Date: 7 August 2007

To: T10 Technical Committee

Subject: SPC-4: Establishing a Security Association using IKEv2

Figure x3 — IKEv2-SCSI Authentication step

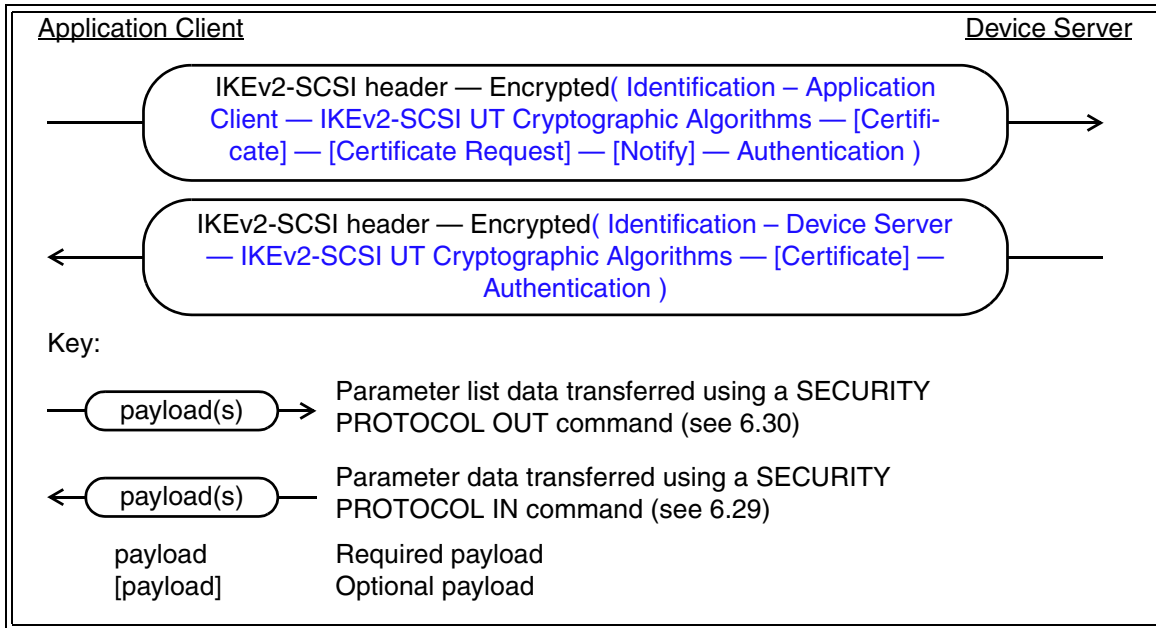
{{The blue in figure x3 is intended for inclusion in SPC-4 and is used in conformance with the T10 Style Guide to assist viewers capable of rendering color to more easily see the encrypted payloads. It is not normative.}}

Figure x4 — IKEv2-SCSI Delete operation

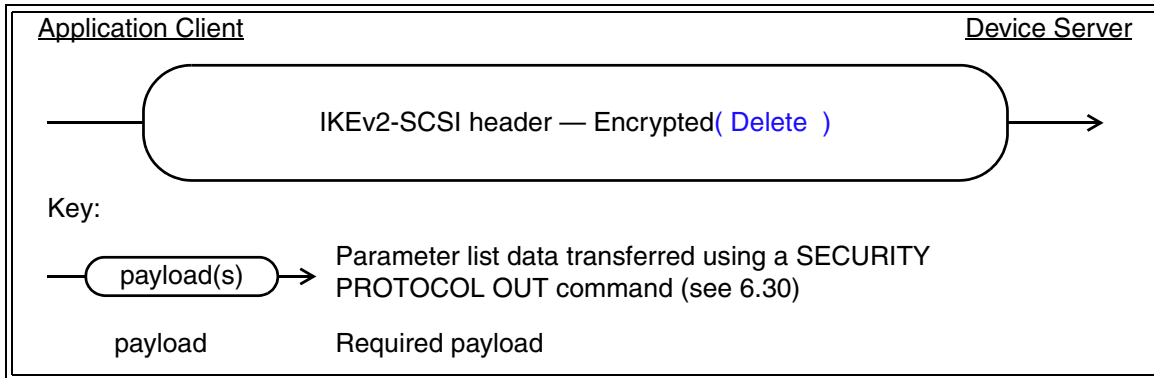
{{The blue in figure x4 is intended for inclusion in SPC-4 and is used in conformance with the T10 Style Guide to assist viewers capable of rendering color to more easily see the encrypted payloads. It is not normative.}}
